# Modification Recommended Service Note

## RP7972A Regenerative Power System

Serial Numbers: MY60000101 – MY60002000

The Problem – Incorrect label of “Float Voltage Rating”.

Figure 1: Incorrect label

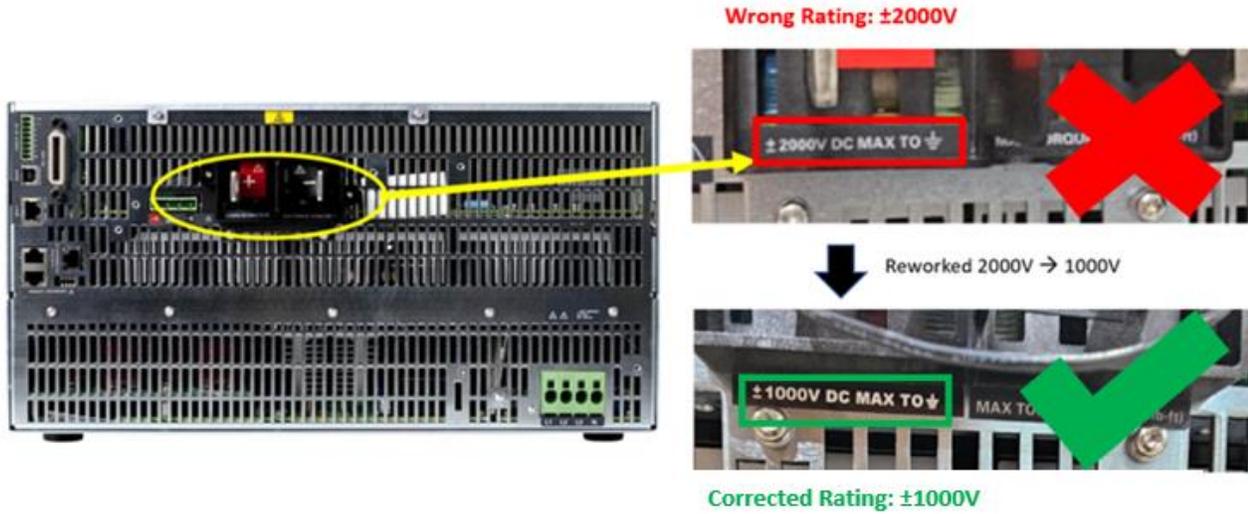
For the Serial Number listed the value of “Float Voltage Rating” has printed incorrectly on the label. The  $\pm 2000V$  label is incorrect and should be replaced with  $\pm 1000V$  label as shown in Figure 1.

When sending the instrument to the service centre for calibration or repair, label will be changed accordingly.
